Village of Arlington Heights
Plan Commission
Board Room
Arlington Heights Village Hall
33 S. Arlington Heights Road
Arlington Heights, IL 60005
October 11, 2017
7:30 PM

- A. PC#16-012 - Ivy Hotel - 519 W. Algonquin Rd.
Land Use Variation for Hotel

PC Project Number: PC 16-012
Project Title: Ivy Hotel
Address: 519 W. Algonquin Rd.
PIN: 08-16-103-008, 08-16-103-009

1 PROPOSED SITE PLAN
SCALE : 1" = 20'-0" AUGUST 8, 2017

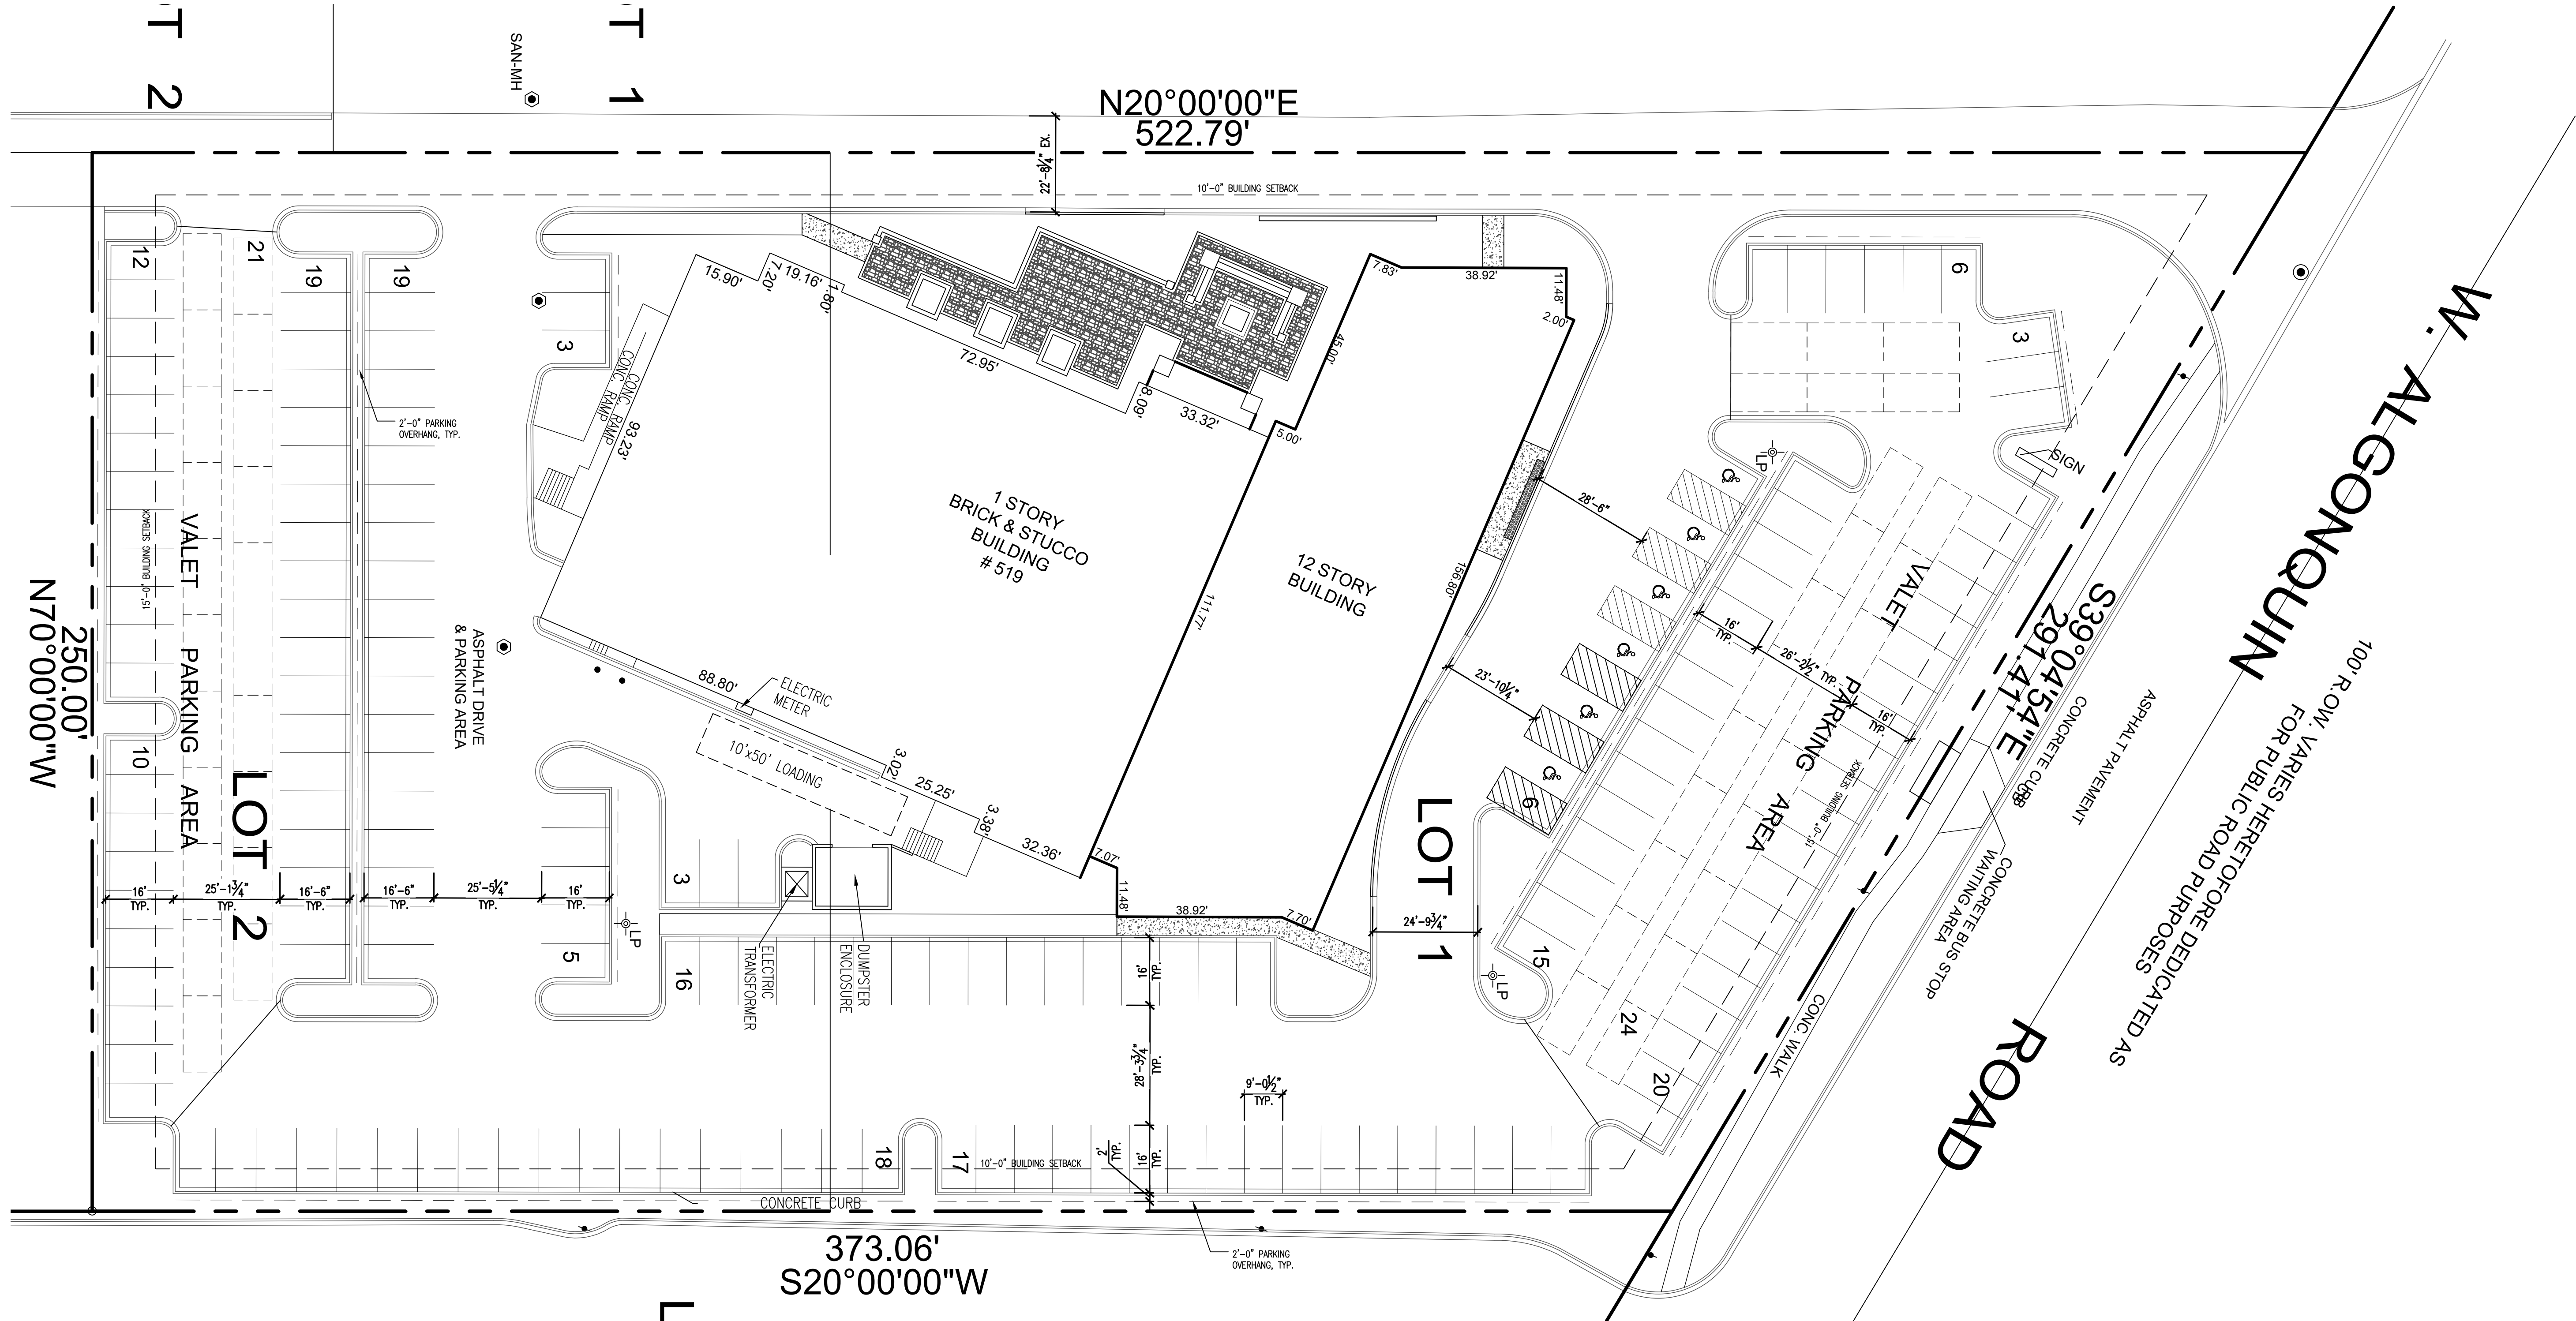
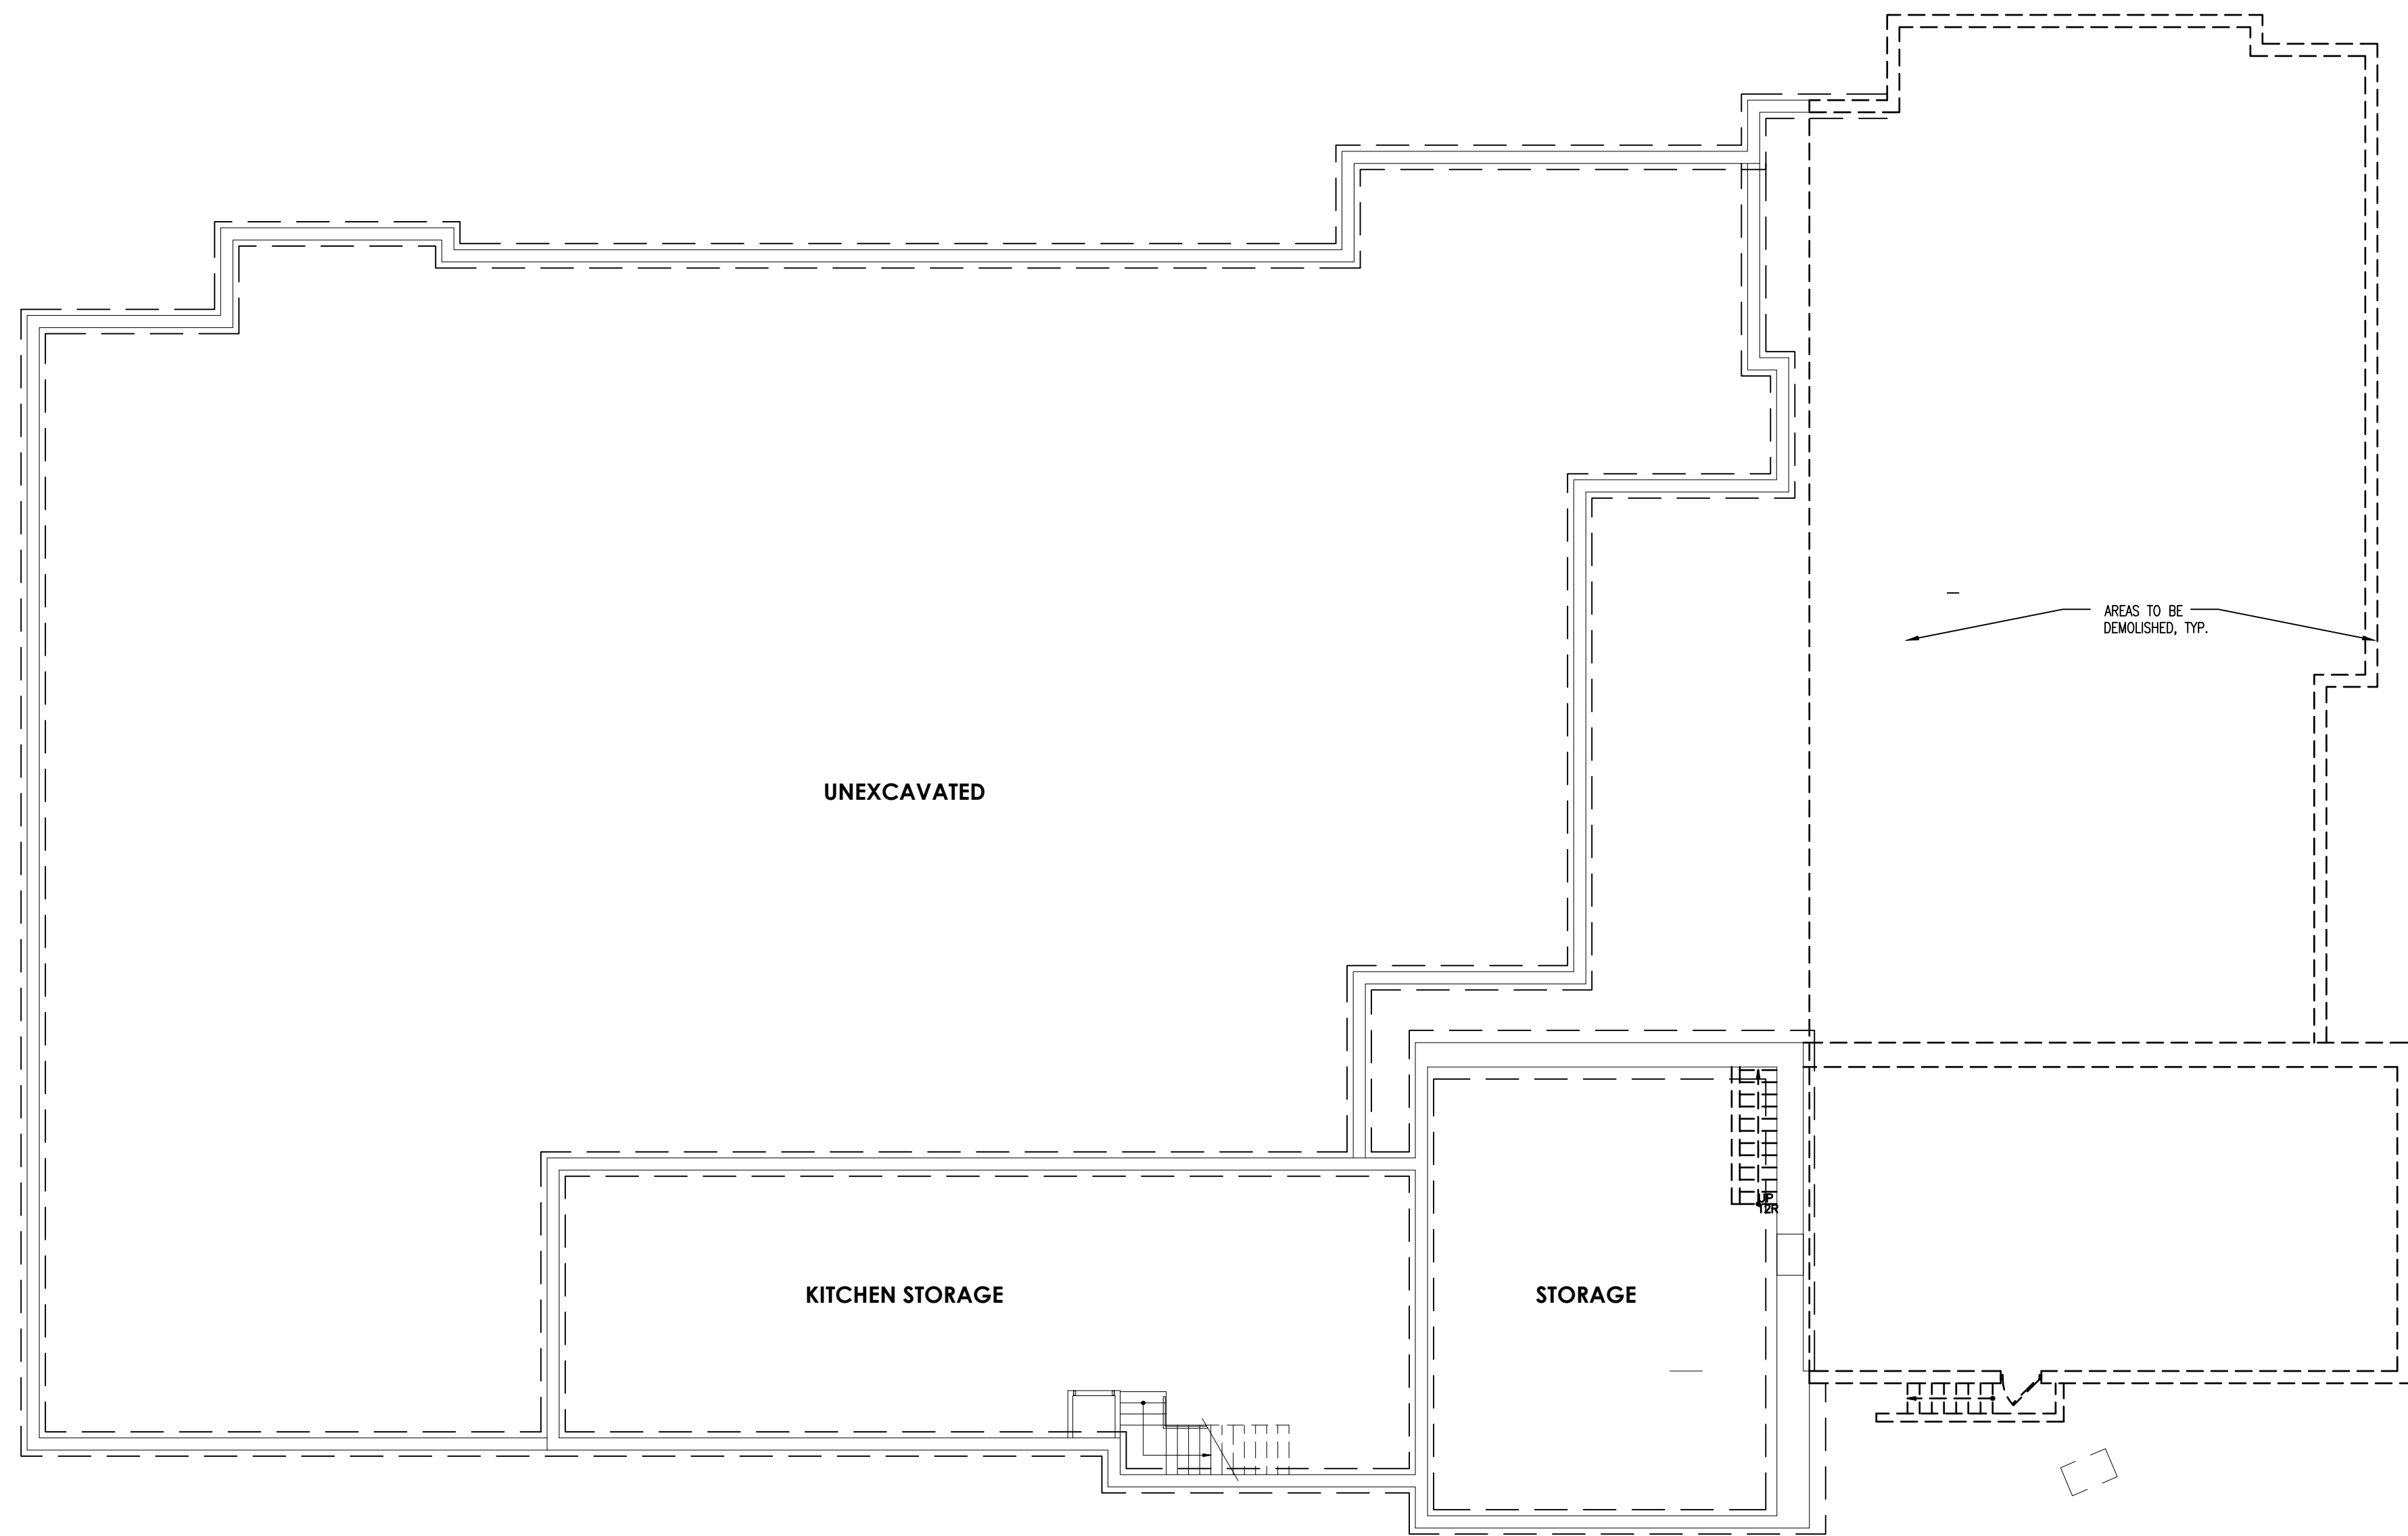
8. Many of the plan sheets are still inconsistent. Specifically:
 - a. The Site Plan (sheet A-0) does not show the new curb and sod area along the western side of the building.

25. The Site Plan (sheet A-0) indicates that there are a total of 150 parking spaces proposed on the site as a result of the Ivy Hotel development. However, 152 spaces are shown on the plan. Additionally, the Site Plan indicates that 25 valet spaces will be provided, however, 27 valet spaces are shown on the plan. Please revise the plan to reflect the actual number of proposed parking spaces and valet spaces. Additionally, please consider that the Ordinance #00-012, which granted the Special Use Permit for the banquet facility, limits valet parking to only the "plan east and west" circulation aisles.

Preliminary Grading Plan

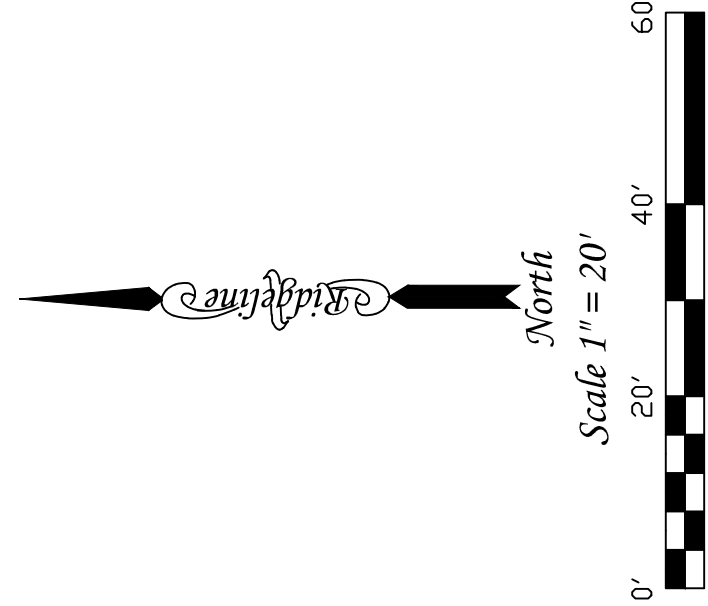
14. The table on Sheet 3.1 breaks down the existing and proposed impervious and pervious areas; however, the proposed numbers don't add up: the total site area will remain at 2.571 acres, but the proposed impervious area of 2.13 acres plus the proposed pervious area of 1.192 acres totals 3.322 acres. Provide accurate proposed numbers. Detention must be provided for any increase in impervious area, per Village requirements. Include a copy of the pertinent parts of MWRD Permit #00-512.

Truck Turning Exhibit

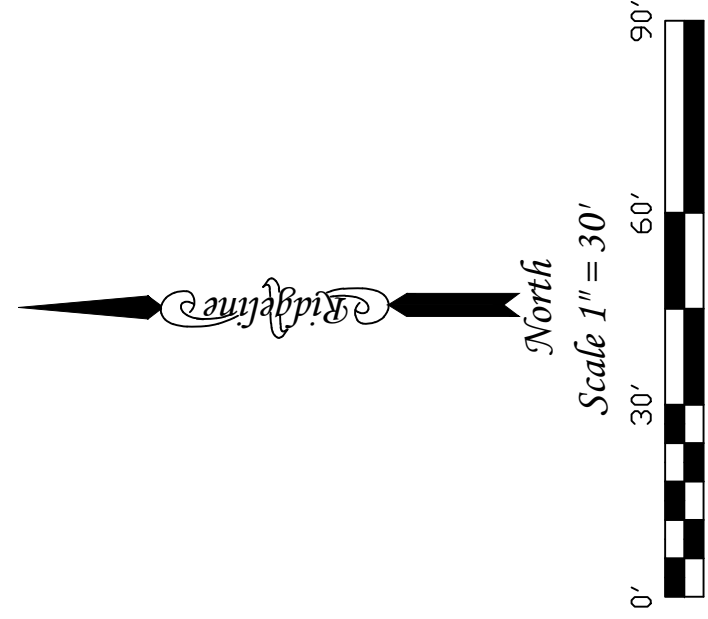
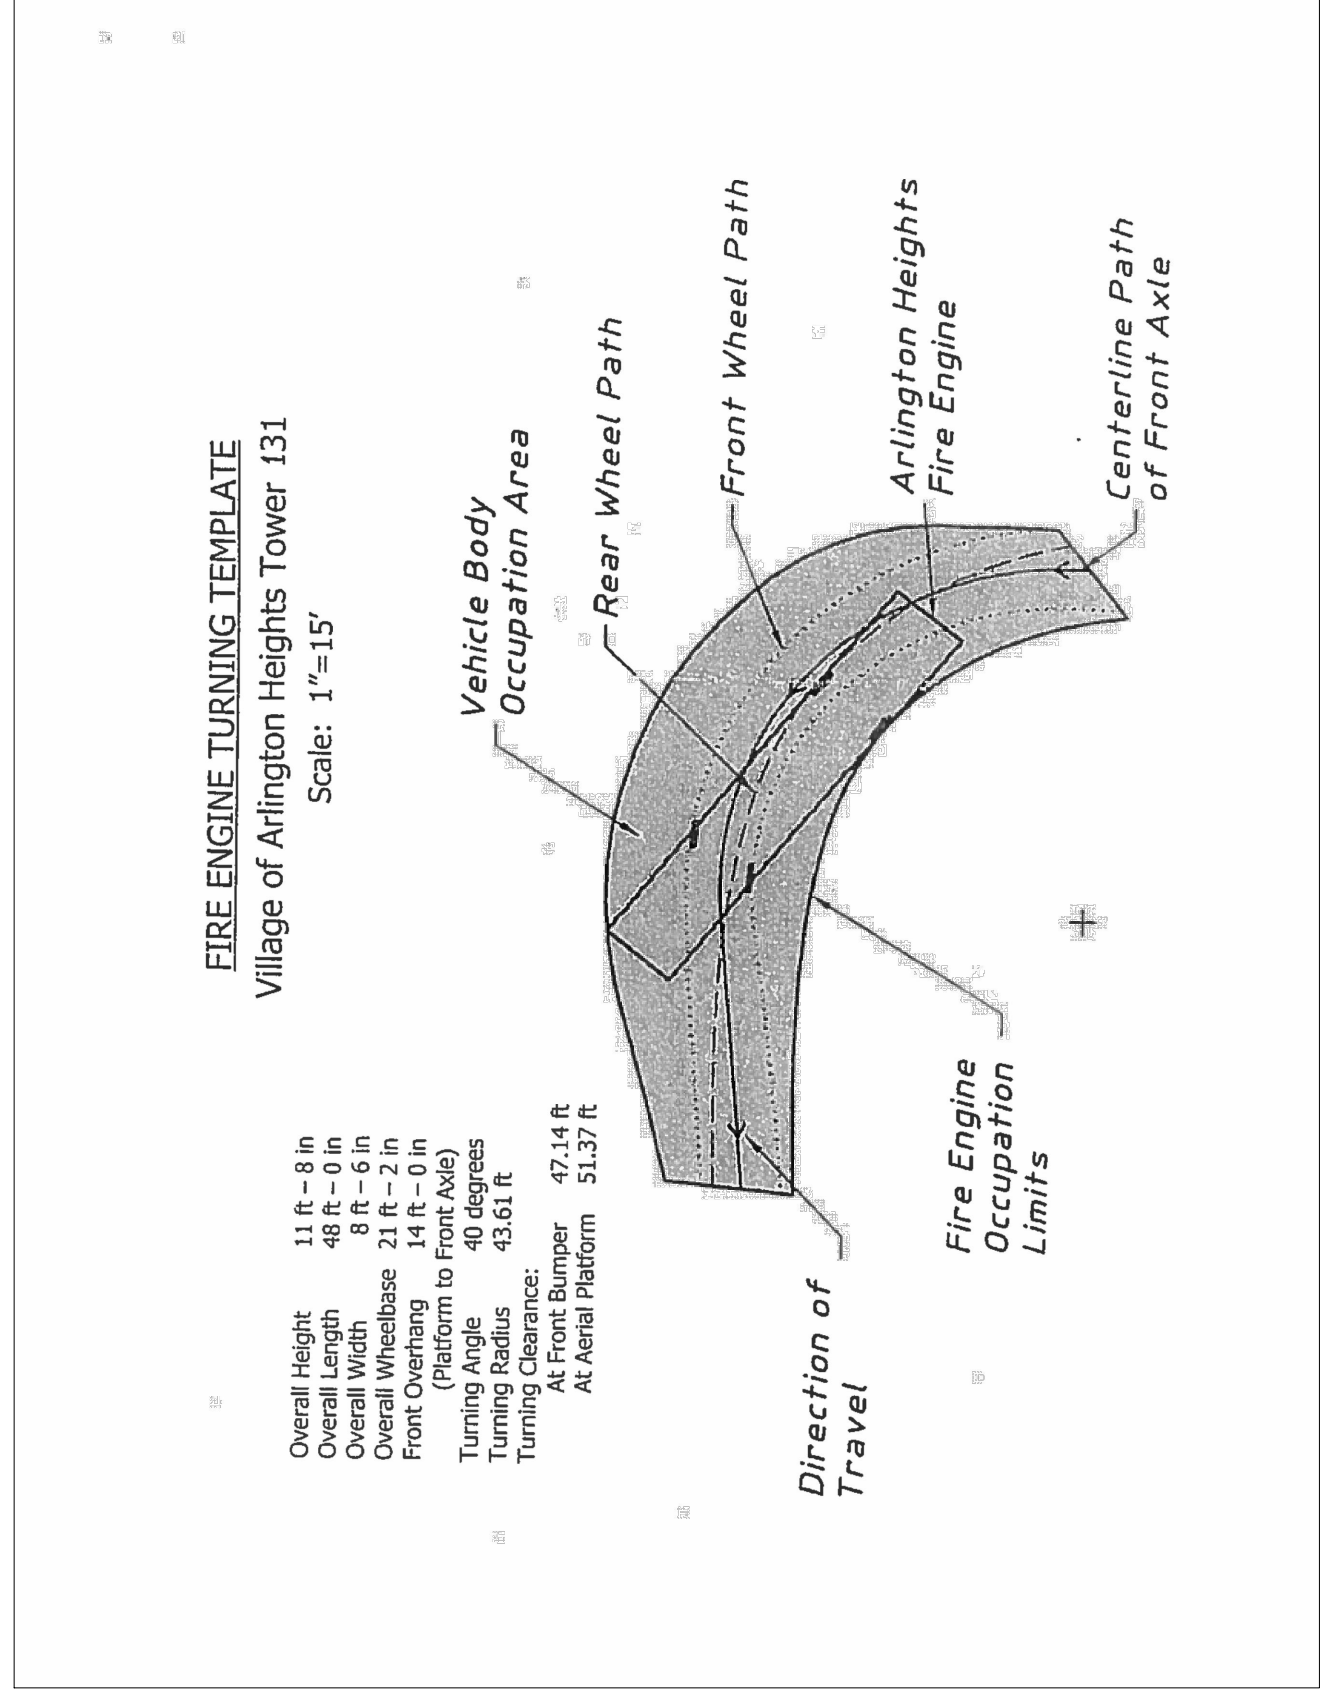
15. Any under pavement stormwater facilities must be designed to handle AASHTO HS-25 loading.
16. The exhibit on Sheet 6 showing the responding vehicle turning path labels the truck as "Itasca Fire Truck 2". Use the enclosed attachment for the Village of Arlington Heights's responding vehicle.
